Accessibility Design Review Report

Proposed Data Centre Development
1 Sirius Lane Cove West NSW 2066

Prepared for: Greenbox Architecture
Job No: 77710
Date: 17th December 2018
Revision: -
Phase: DA Submission

AWE Doc No Added 110319
ATSYD2-SSD-REP-ACC-001

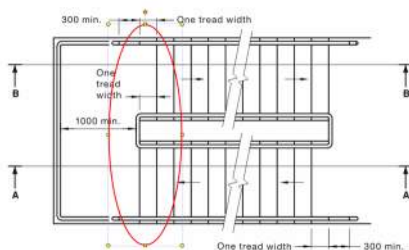
Circulation stairs and ramps will be required to be set-back from transverse paths of travel so that handrail extensions do not protrude into corridor paths of travel.

Offsetting the stair at the mid landing will allow a continuous single handrail which will not require vertical sections.
